We Can Do Better

PHASE1ESA.CA
DUE DILIGENCE DONE RIGHT

CASE No. 1

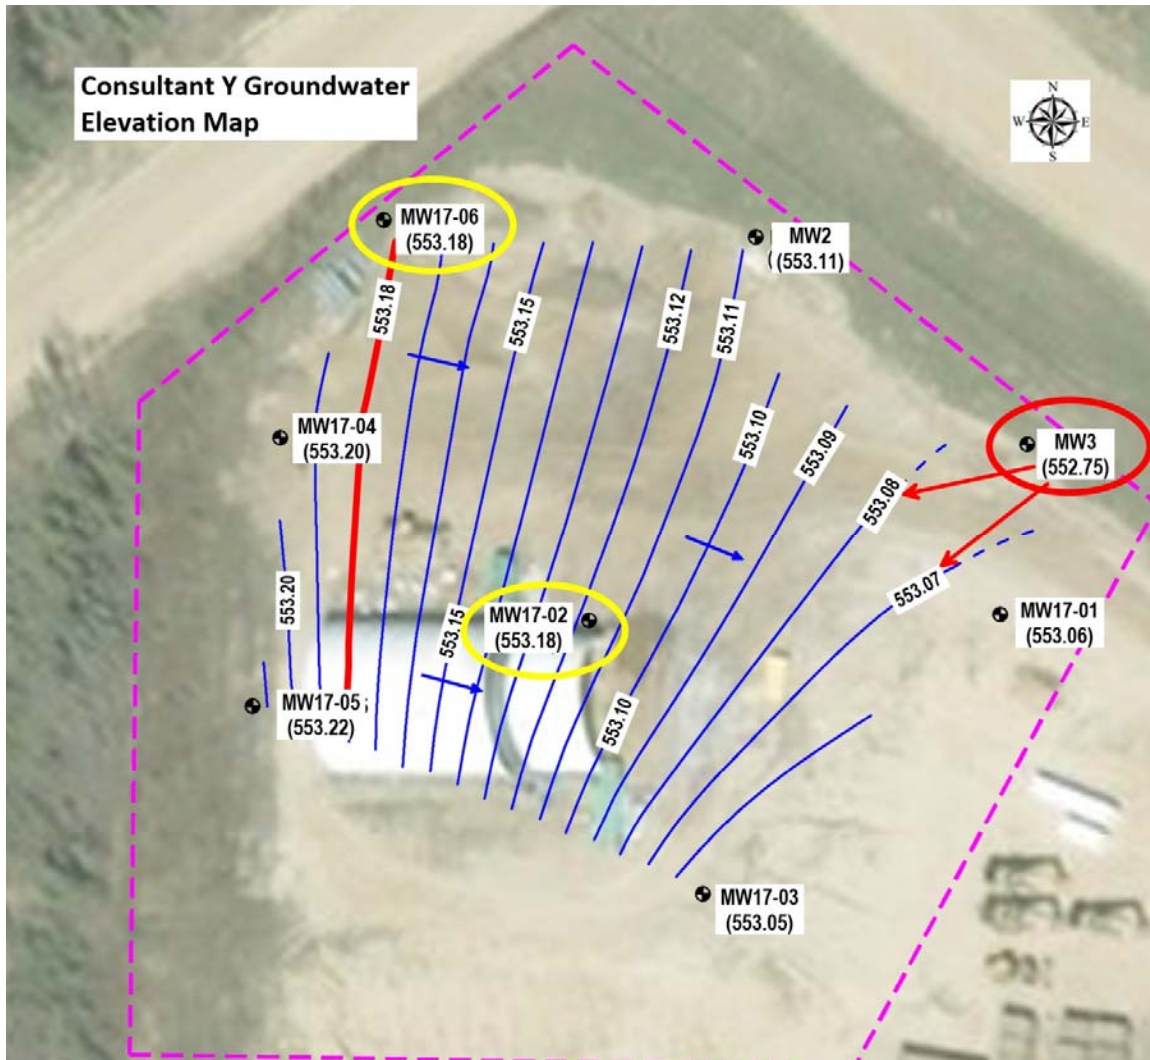
Can you tell where the problems are with this map? There are two of them.

MW17-02's and MW3's elevations don't fit with the groundwater elevation contours. The map doesn't reflect the data. Two data points have been ignored in the plot but no explanation of why was given anywhere in the report.

This was the actual cross section from Consultant Y's report. Can you spot the problems with it? There are several.

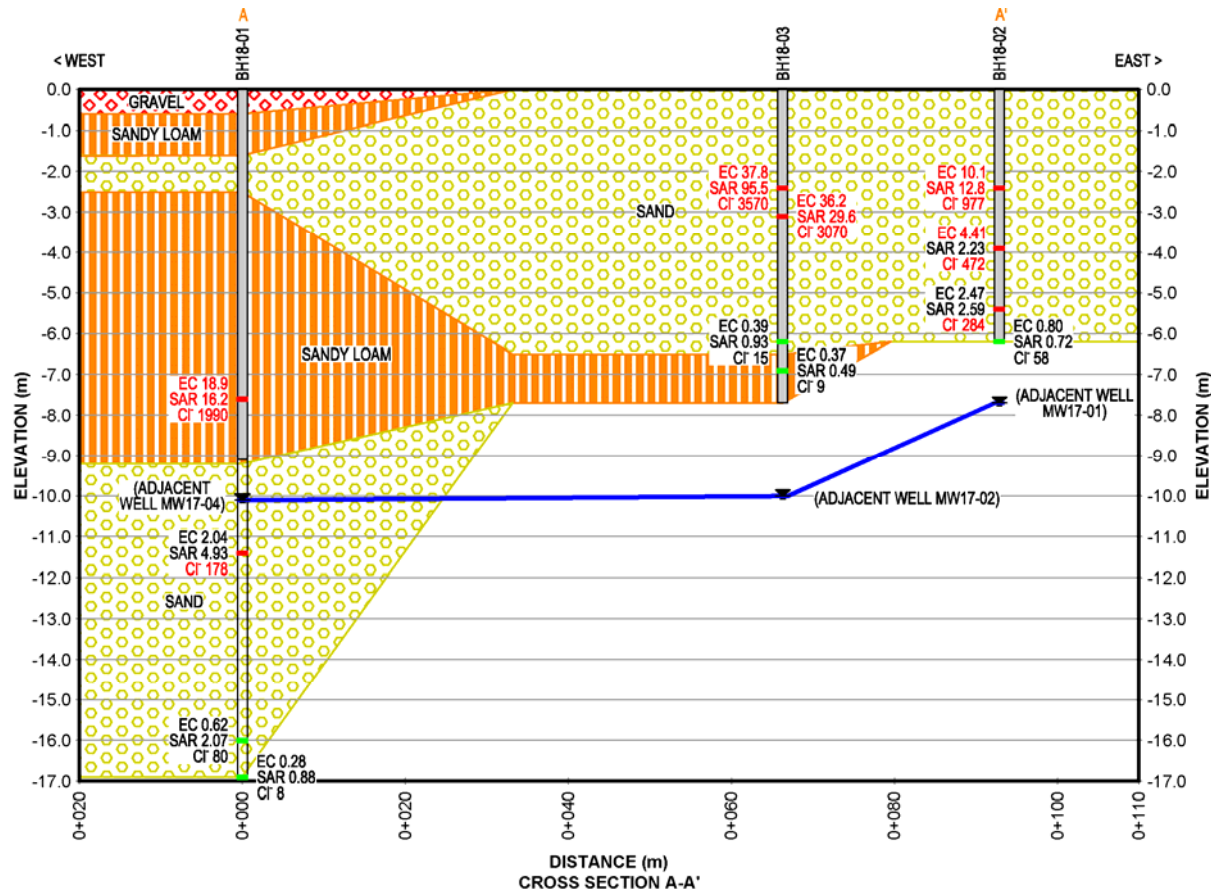
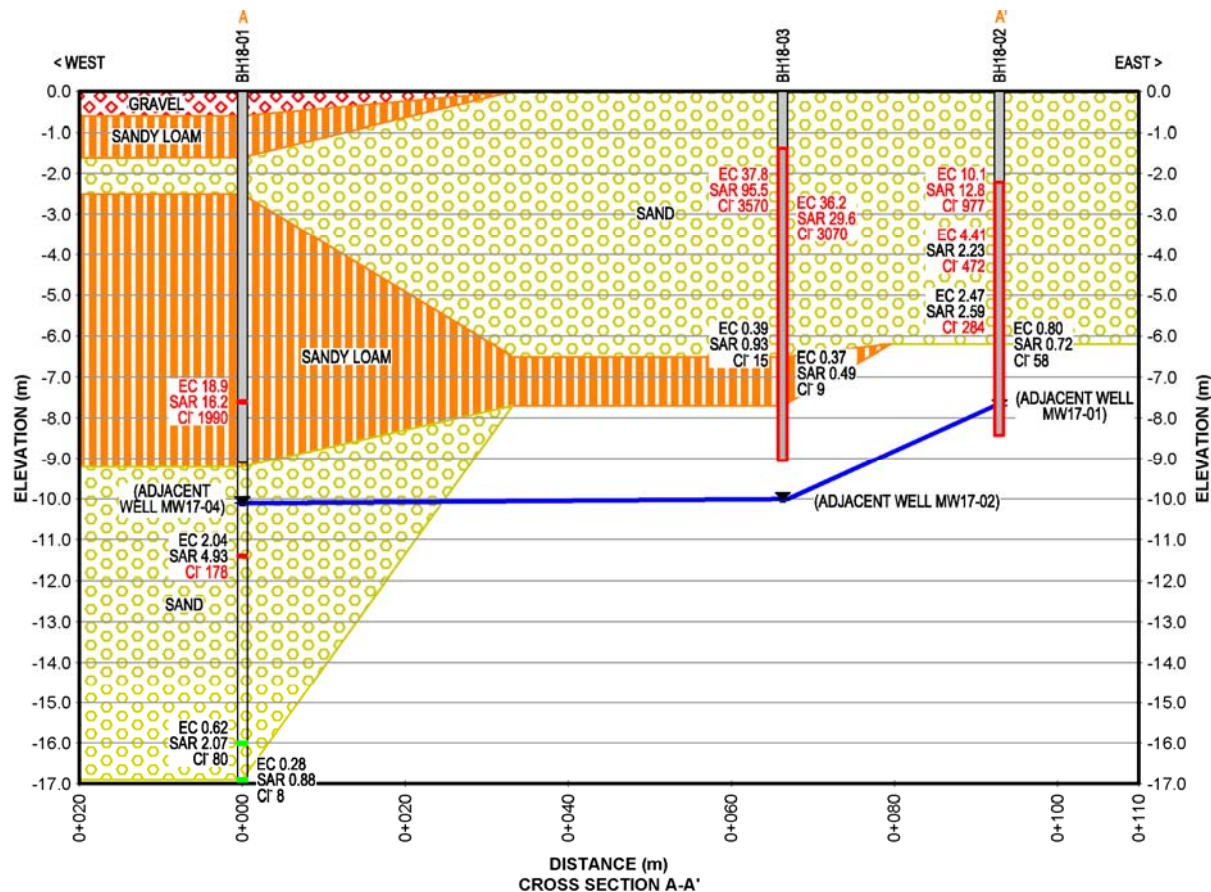
The total depths of all 3 boreholes are correct and the depths to the different zones from ground surface at all three boreholes are also correct. The problem is, all three wells are at different elevations with the difference in elevation between BH18-01 and BH18-02 being -2.17m.

The X-section is **wrong and misleading**. The elevations of all the lithological contacts are incorrect at the east end of the X-section. The red outlined well bores show where the east boreholes should've been plotted. The zone contacts, etc., should be shifted downwards the same amount.

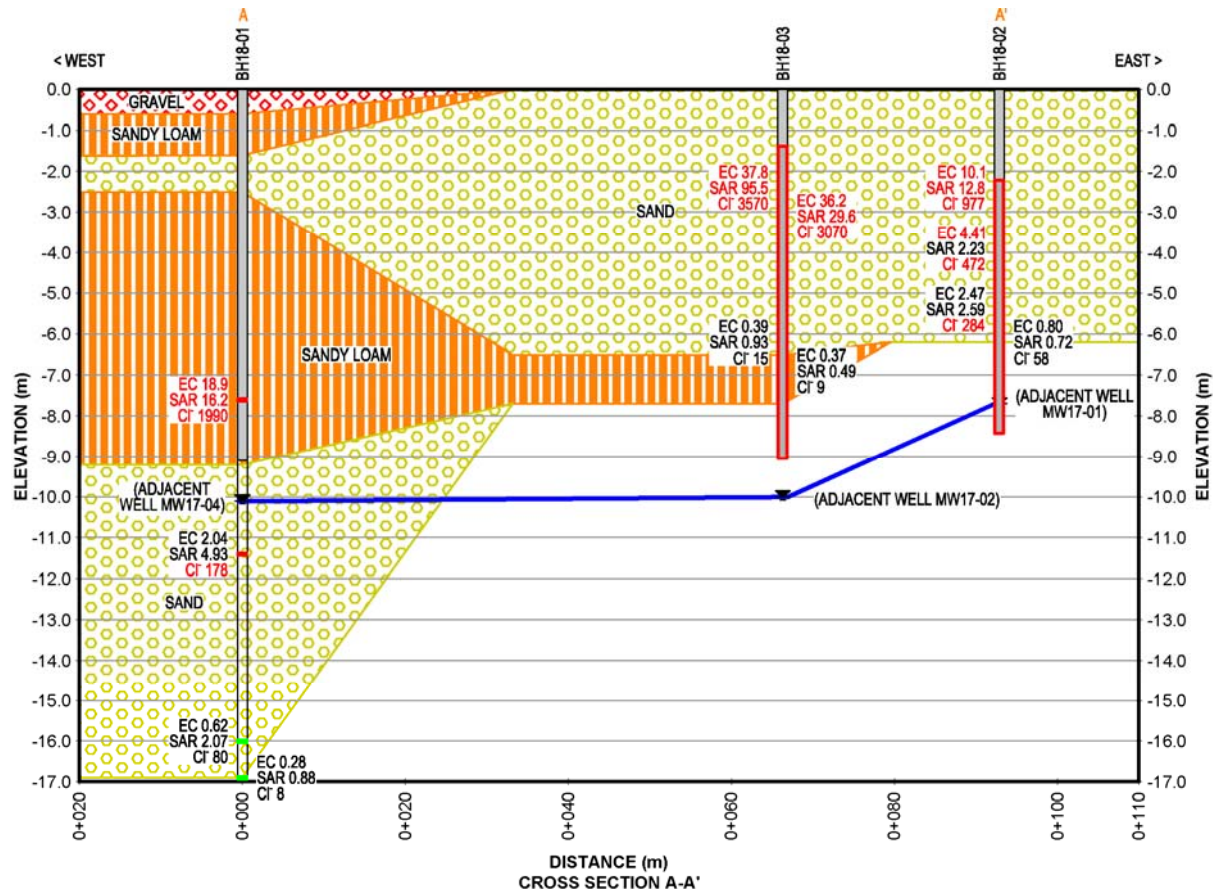
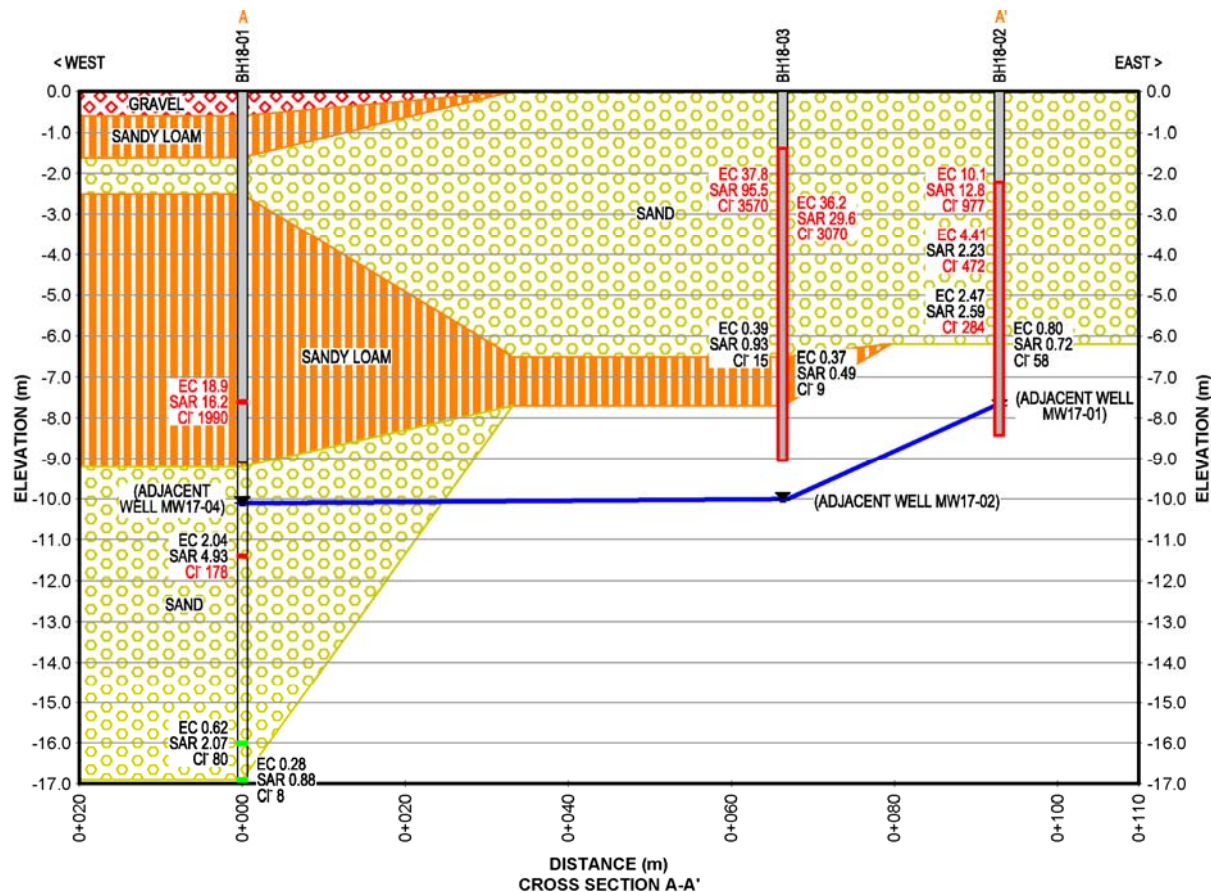
The groundwater elevations are wrong as well. The groundwater elevations at MW17-02 and 01 are 0.02 m and 0.14 m lower than at MW17-04, respectively. This figure shows that groundwater elevations are higher at the two east wells. This is false.

Remember how the groundwater elevation contour map clearly showed the groundwater flow direction was **west to east**? This cross section shows it flowing **east to west**.

How was this missed in 2011?

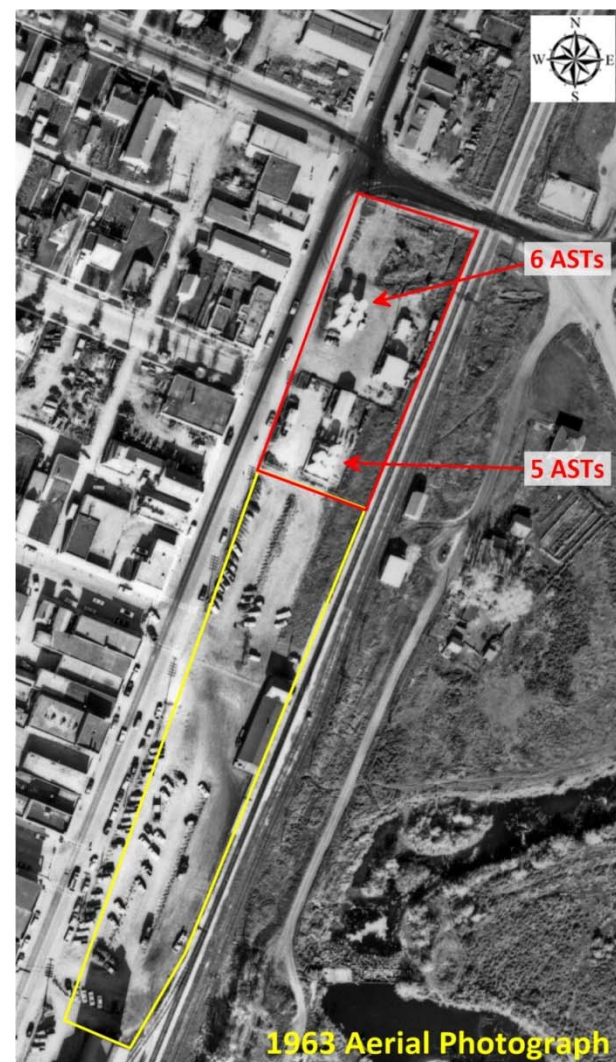
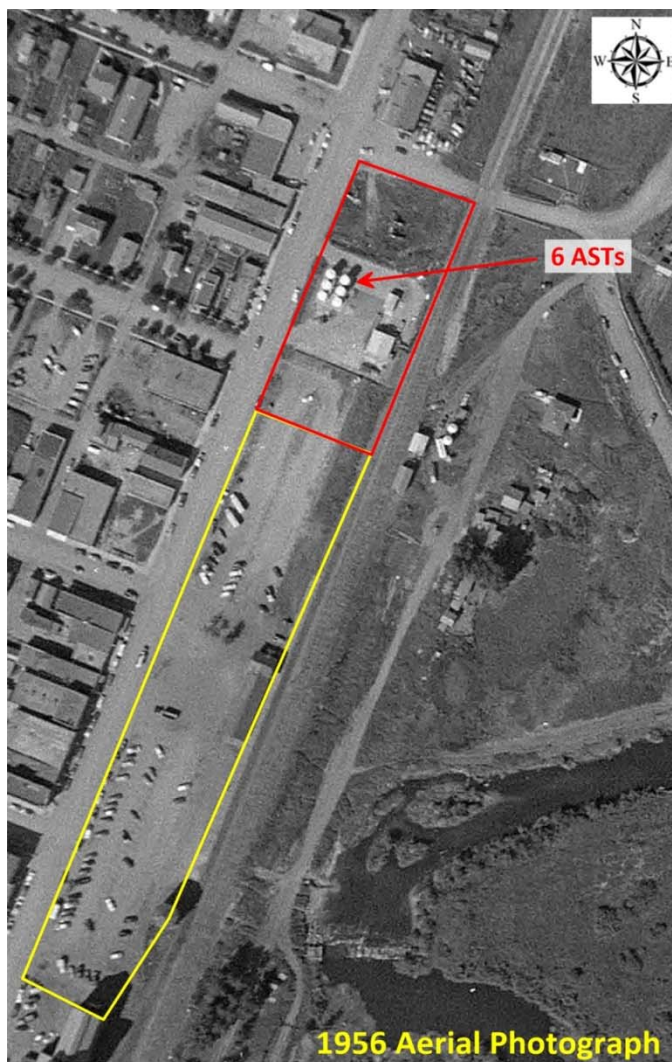
It is hard to imagine how the new development and the presence of the ASTs in the adjacent lot to the north could've been completely missed during the AP review. Inexperienced and/or poorly trained reviewer?

Why wasn't this glaring (and potentially dangerous from a legal liability aspect) omission not caught during the review process?

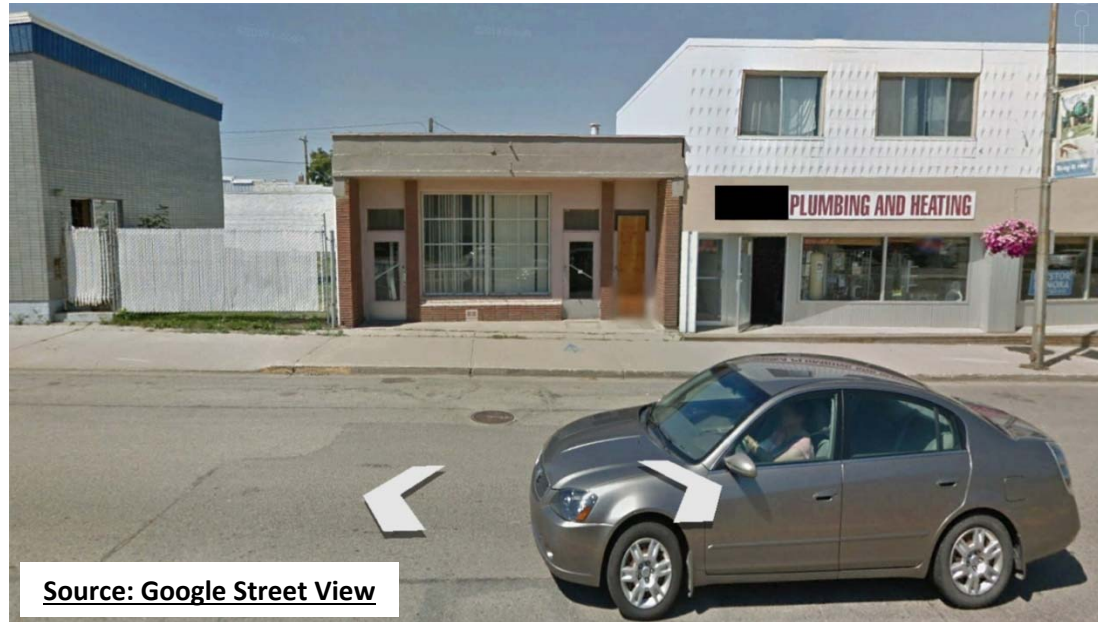
YES! During the site inspection they could've simply looked across the street and observed what was there.

An abandoned and boarded up commercial property on a prime commercial strip often indicates a contaminated site.

The above Google Street View image is from 2015. The property was abandoned ~2007 so this is what they would've seen in 2011.

**Consultant A 2006 Groundwater
Monitoring Well Locations**

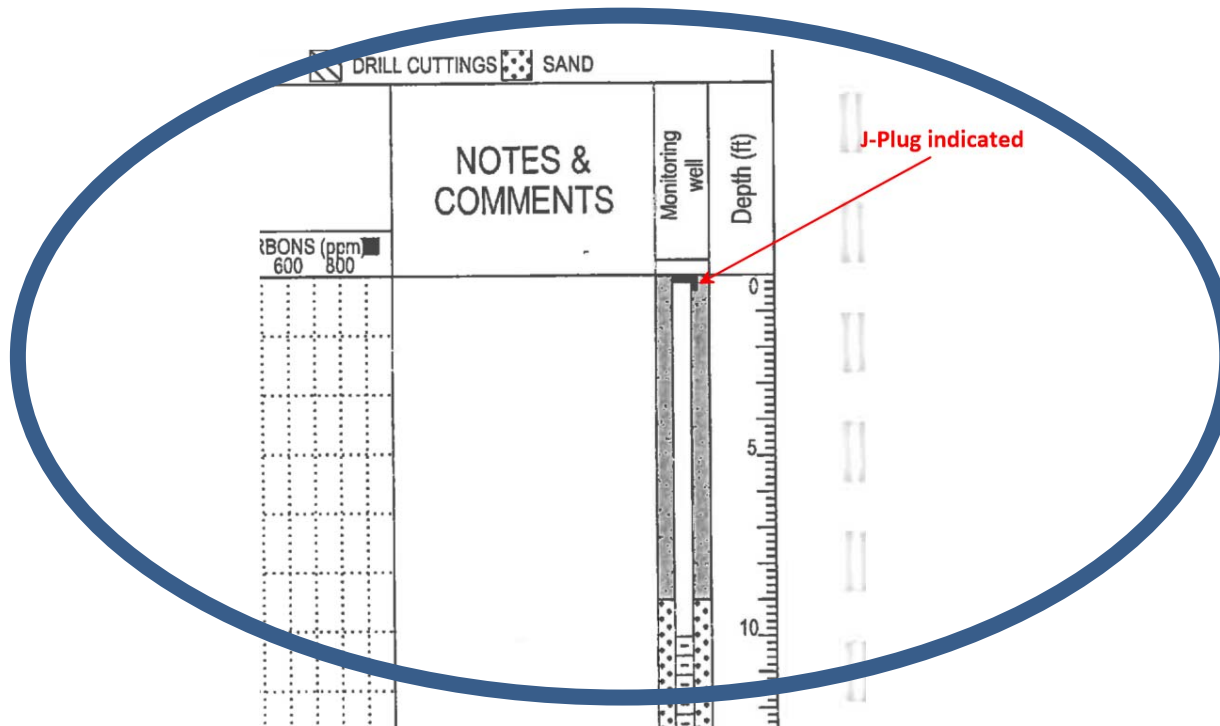
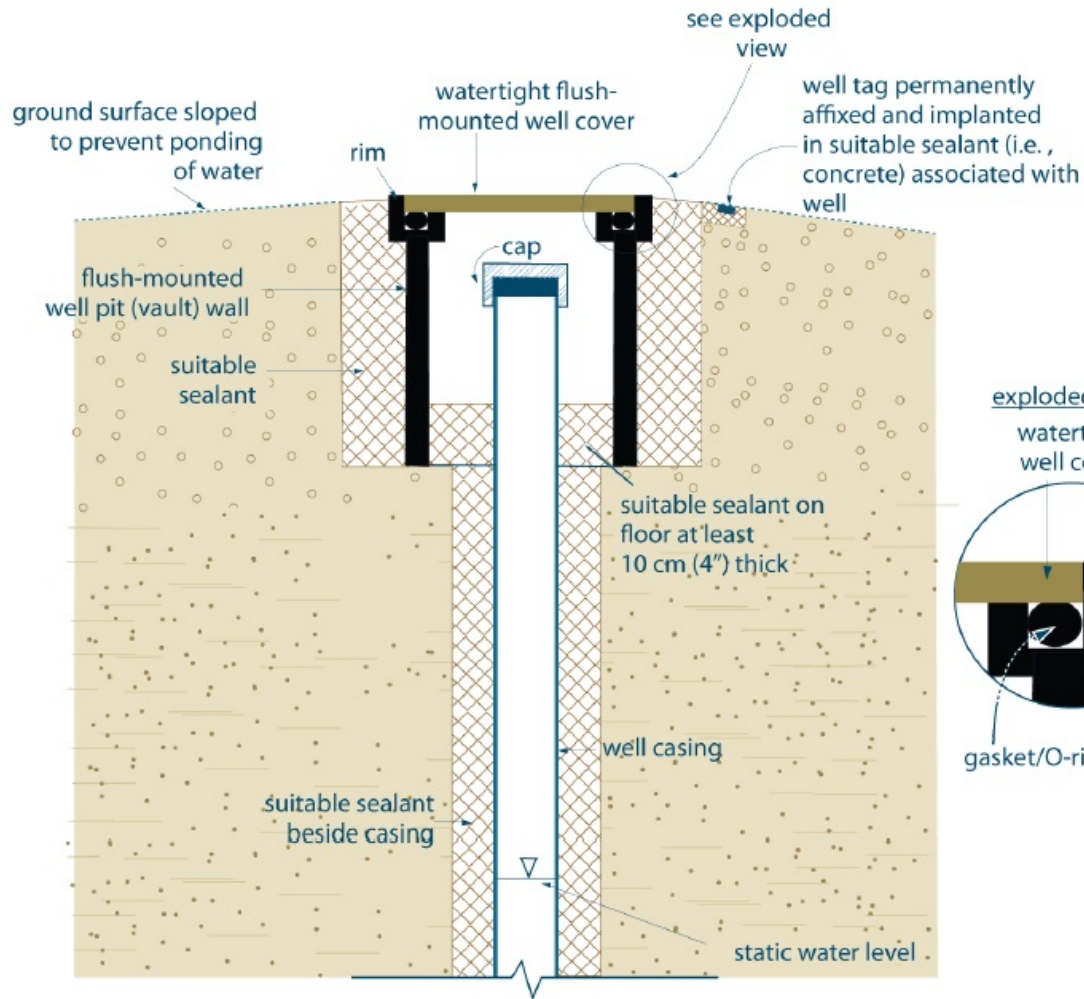
Consultant A then attempts to conduct a Groundwater Elevation Survey to determine the direction of shallow groundwater flow but they botched it and then said the attempted survey yielded no useful results.

What they did shows Consultant A's Field Techs and the report writer were inexperienced/not well trained and did not know how to conduct a proper groundwater elevation survey. It's possible that the person who reviewed and signed off on the report didn't either.
